City of Aurora Building Division
Reviewed for Code Compliance
Approved as Noted: *Rhonda Ritter*
Date: *Feb 08, 2018*
2015 INTERNATIONAL CODES & 2014 NEC

THE MEDICAL CENTER OF AURORA RENOVATIONS

MECHANICAL PHASE VII-A - PACU & OR

M1.07A

HVAC PLAN - PHASE VII-A - PACU & OR

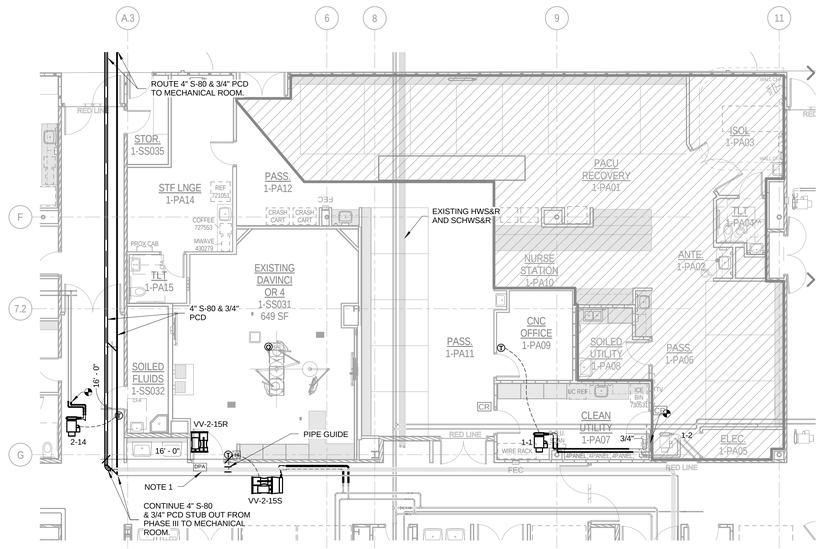
Removal of dampers at these locations is approved per 2015 IEBC 804.1.1. Corridor wall at this location (adjacent to Room 1-SS032) is now considered a smoke partition. Space around ducts and air transfer openings shall be filled with an approved material to limit the free passage of smoke. 2015 IBC 710.8
